February 4, 2020

Re: Environmental Assessment Certificate (EAC) #E14-02: Schedule A (Project Description) & Design of Highway 29 Crossings at Farrell Creek, Dry Creek and Lynx Creek – Proposed Amendments

The purpose of this letter is to seek amendments to Section 4.3.4.1 (Table 4.5) in Schedule A of the Project's Environmental Assessment Certificate #E14-02 ("EAC"). These amendments relate to changes in the design of the Highway 29 crossings for Farrell Creek, Dry Creek and Lynx Creek which have been made based on information obtained through geotechnical investigations and stability analyses. Specifically, BC Hydro proposes that:

Figure 4.30 General arrangement of Highway 29 realignment segment at Farrell Creek			
Date	Nov. 23, 2012	DWG NO	1016-C14-B6158-16 R 0

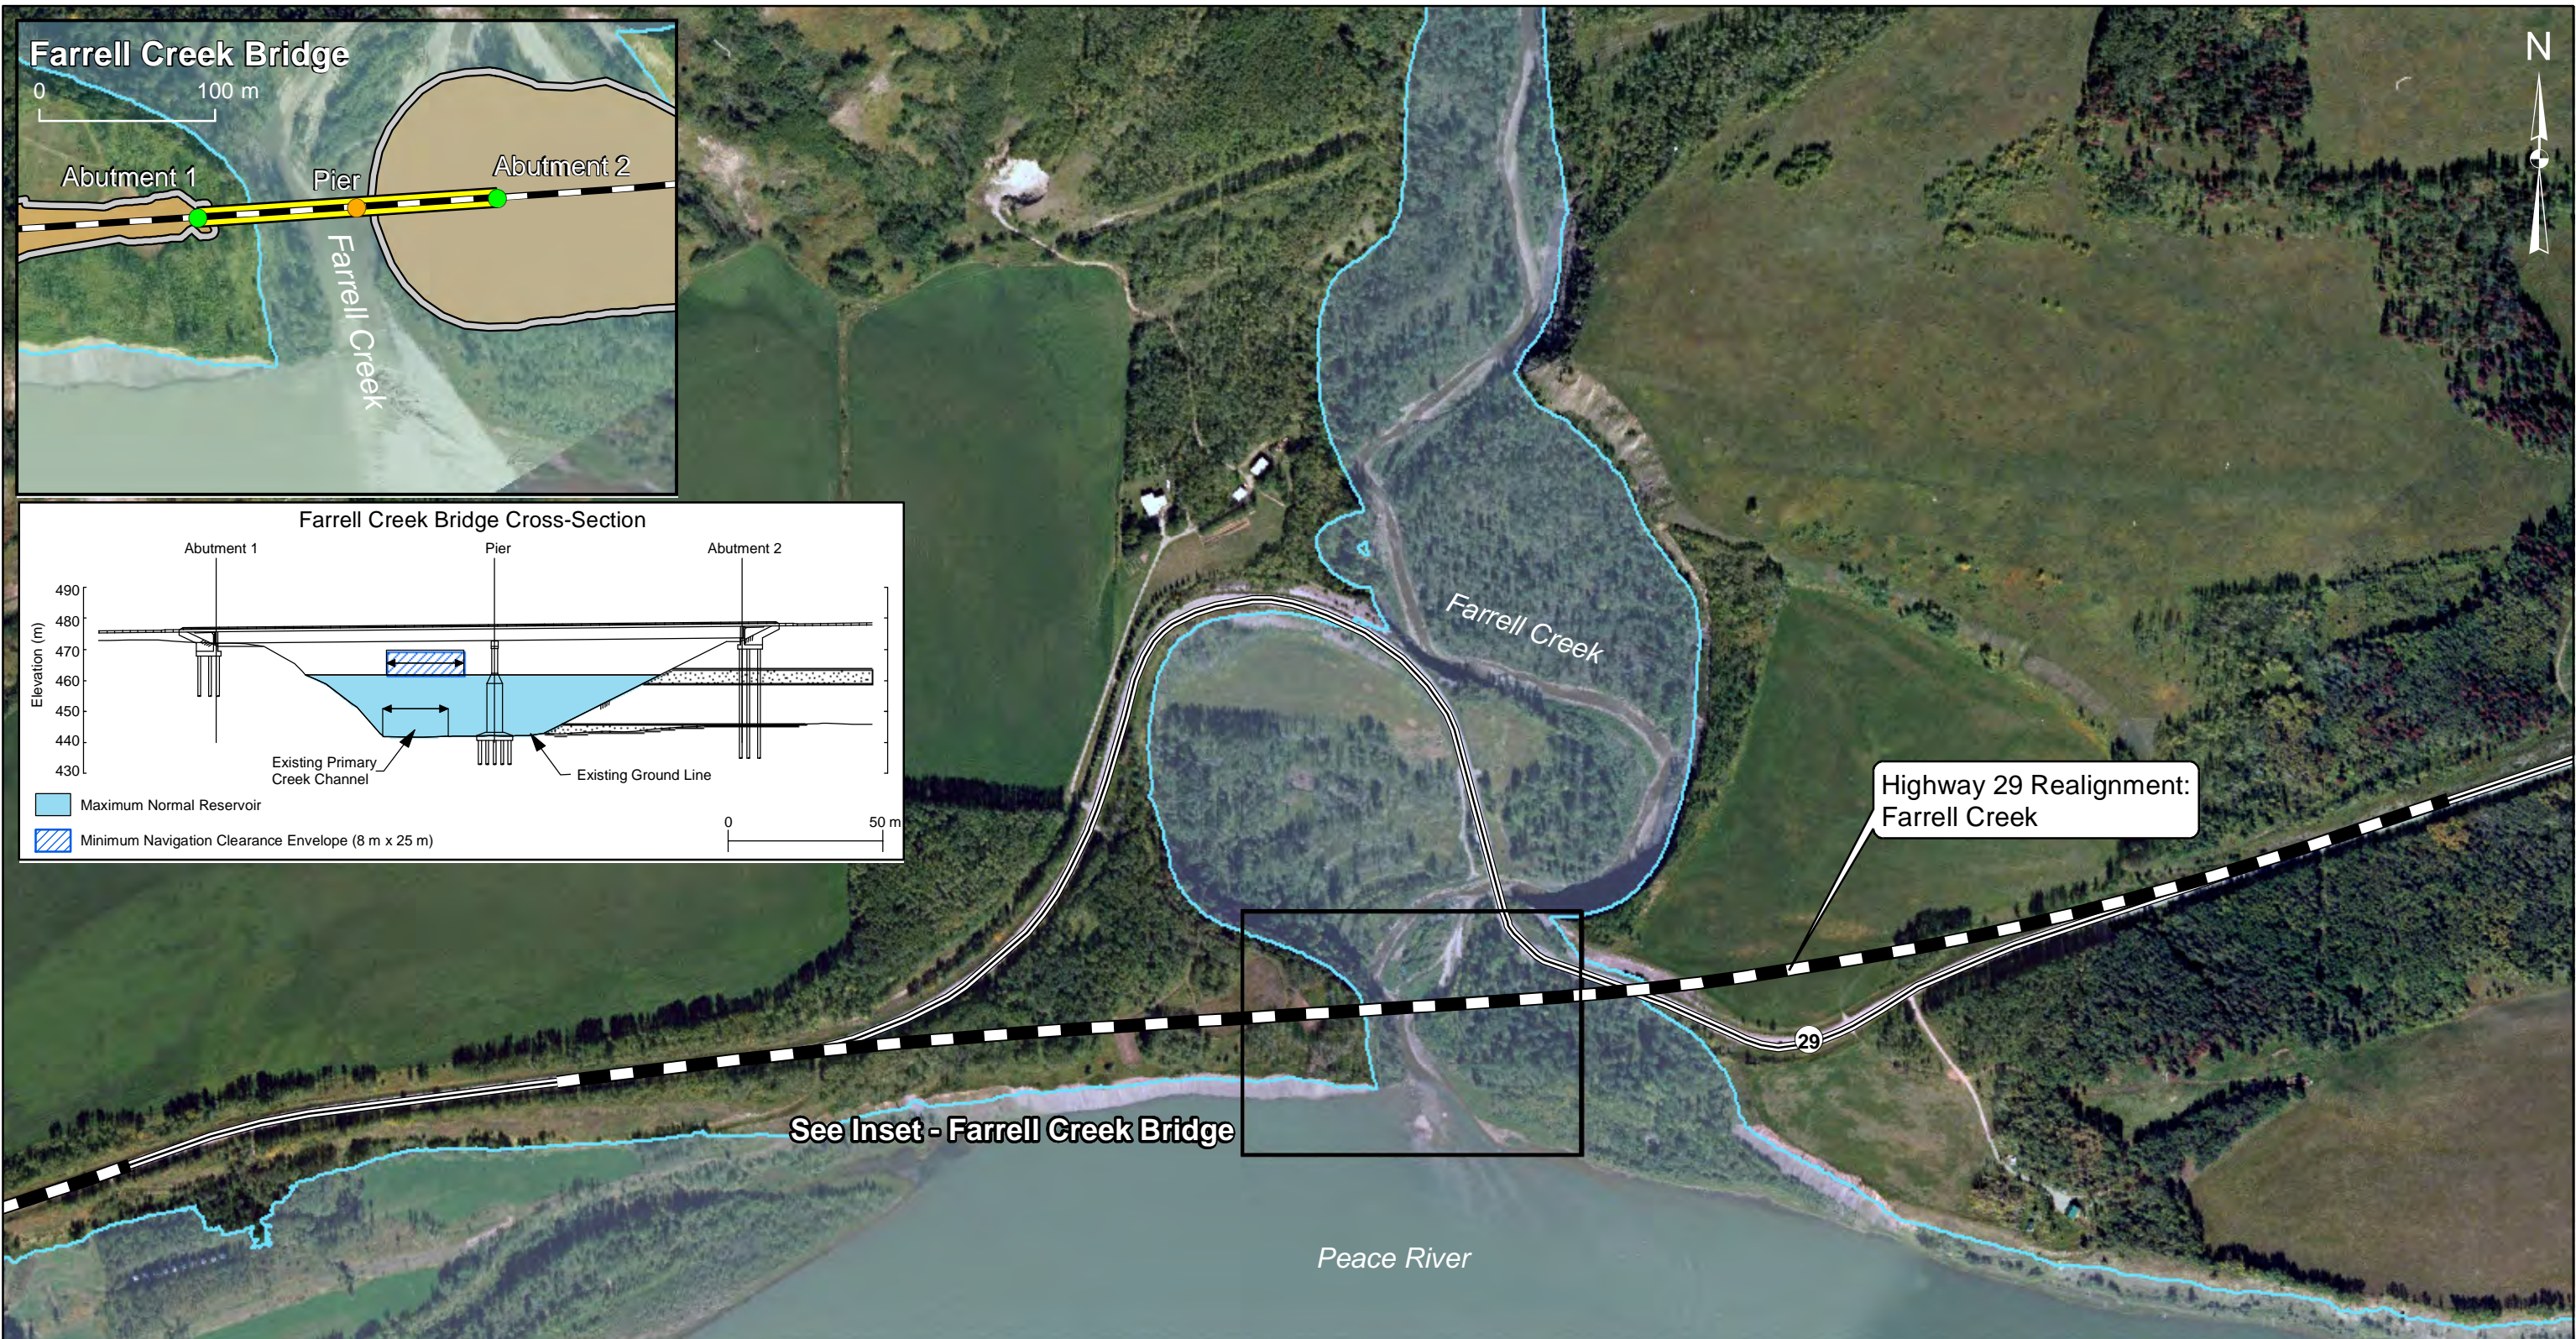
- **Farrell Creek Crossing:** Geotechnical investigations indicated that a zone of weathered shale exists between sand / gravel layers and shale bedrock at the Farrell Creek crossing. Given this information, geotechnical engineers determined that the planned causeway could only be made safe by flattening the causeway slopes and excavating and replacing the weak foundation soils with granular material. BC Hydro determined that this approach was not viable due to (a) a potential lack of locally sourced borrow and granular material; (b) slow construction progress due to additional excavation and foundation fills; and (c) associated construction costs. In the spring of 2019, BC Hydro therefore determined that the most cost effective alternative was to eliminate the short bridge plus causeway option, and to pursue a long bridge option, with conceptual parameters as described in Table 1: a bridge up to 450m in length, no causeway, and up to six piers.

BC Hydro is proposing to replace the EAC approved short bridge plus causeway option with a long bridge without a causeway that will be up to 450m long. BC Hydro is therefore requesting the following revisions to EAC Schedule A, Section 4.3.4.1, Table 4.5:

Component	Text from EAC Schedule A Project Description	Requested Amendments to Schedule A Project Description
Highway 29 Realignment	Section 4.3.4.1, Table 4.5: Highway 29 Realignment Segments and Respective Watercourse Crossing Lengths	Section 4.3.4.1, Table 4.5: Highway 29 Realignment Segments and Respective Watercourse Crossing Lengths
Farrell Creek Crossing	For Farrell Creek: Total Length of Segment: 2.0 km Causeway Length: 150 m Bridge Length: 170 m Number of Piers: N/A ⁴ Number of Bridge Spans: 2 Figure Number: Figure 4.30 Rev 0 (attached as Appendix A, Figure 2)	For Farrell Creek: Total Length of Segment: 2.0 km Causeway Length: 0 m Bridge Length: up to 450 m Number of Piers: up to 6 Number of Bridge Spans: up to 7 Figure Number: Figure 4.30 Rev 1 (attached as Appendix A, Figure 3)

Figure 4: Profile of Farrell Creek Bridge, per EAC Schedule A Design (not to scale)

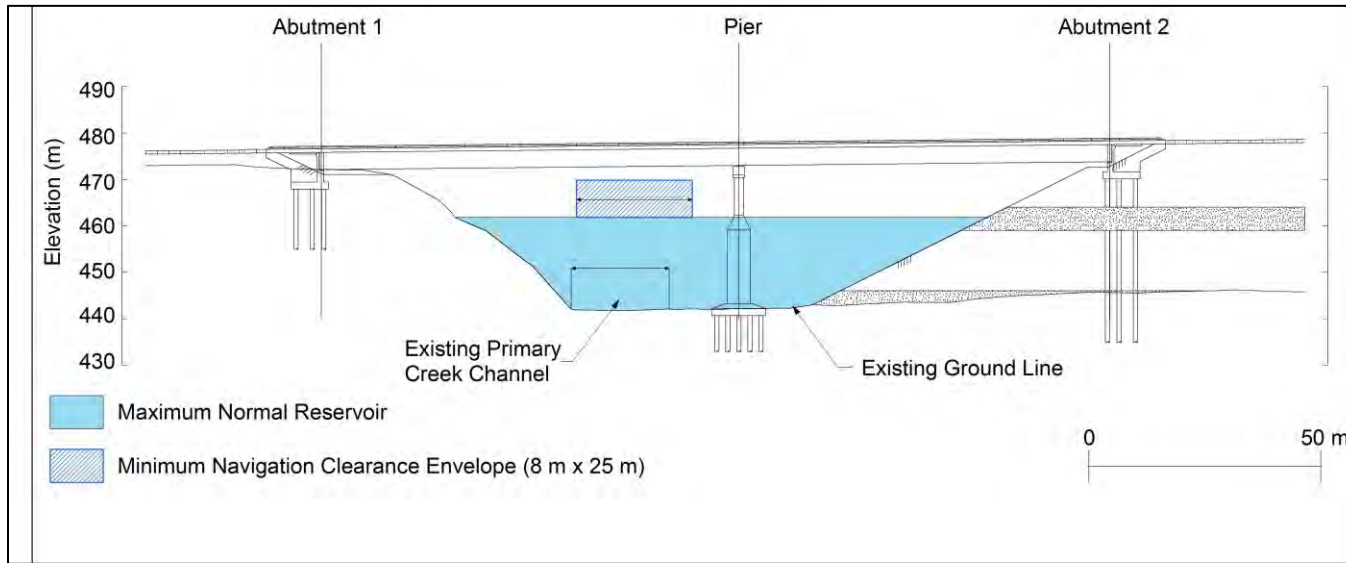
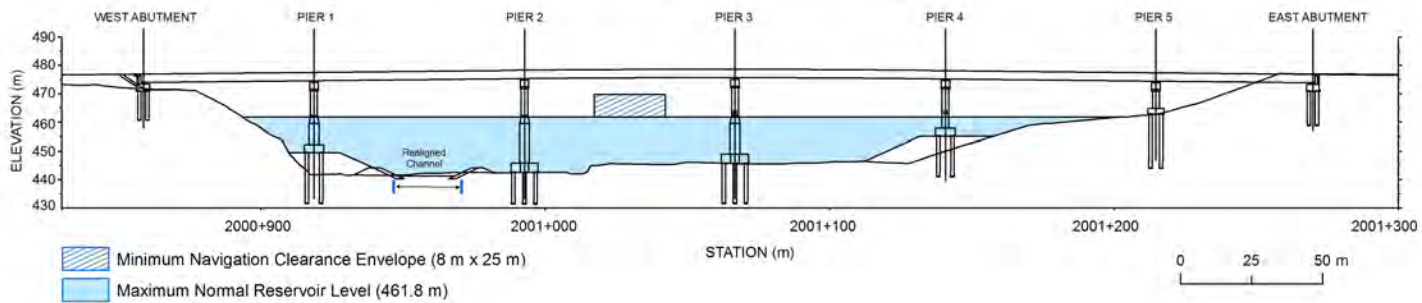
A includes a single pier and a minimum navigation clearance envelope equal to 8m high (as measured from maximum normal reservoir elevation, 461.8m) and 25m wide (Figures 4 and 5). During the environmental assessment, Transport Canada provided an analysis that resulted in the recommendation that the Farrell Creek Bridge design contain a clearance envelope that is 8m high, as measured from the 461.8m reservoir elevation level, and 25m wide.⁵ The proposed revised bridge design meets these requirements.

**Figure 6: Farrell Creek Bridge -
EAC Schedule A Design vs Revised Design**

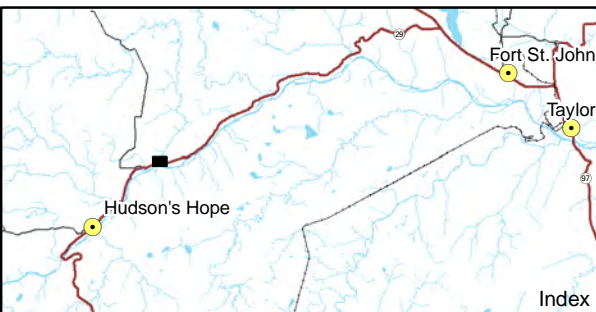
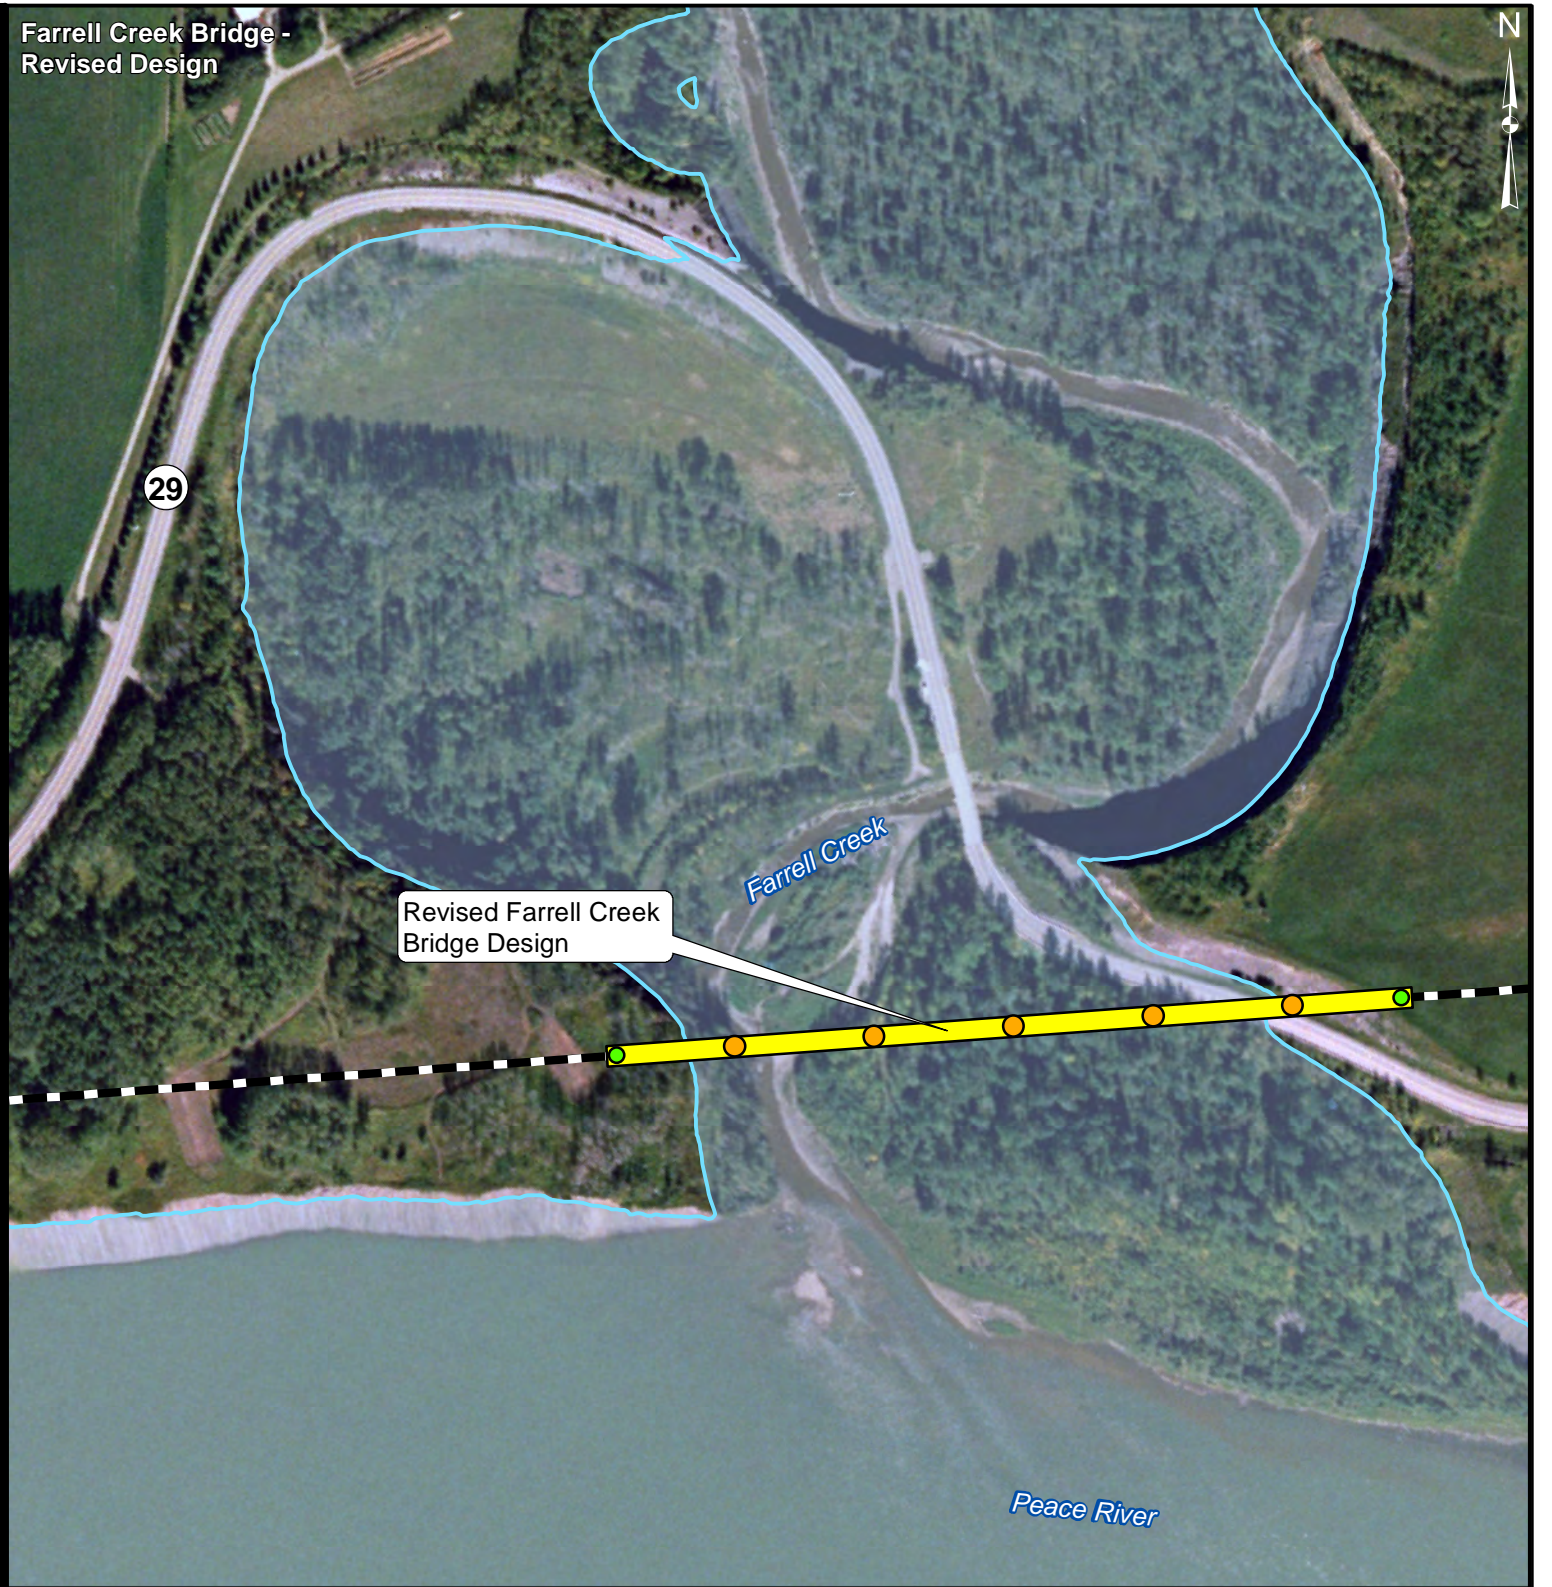
As shown in Figures 2, 3 and 6, the proposed design changes to the crossing will not materially change the alignment of the crossing, with the revised bridge design a few degrees offset from the EAC approved causeway. Overall, the removal of the causeway will reduce the environmental impact of construction below the future reservoir during the years leading up to inundation.

The proposed modification to the Farrell Creek Bridge design is not expected to cause any additional effects on vegetation and ecological communities or wildlife resources beyond those predicted in the EIS. As shown in Figure 6, the 150m causeway per EAC Schedule A design will be replaced by piers in the proposed revised design. This change does not increase the terrestrial footprint of the Farrell Creek crossing. Therefore, this revised design would not change the conclusions of the EIS regarding vegetation and ecological communities, or wildlife resources.
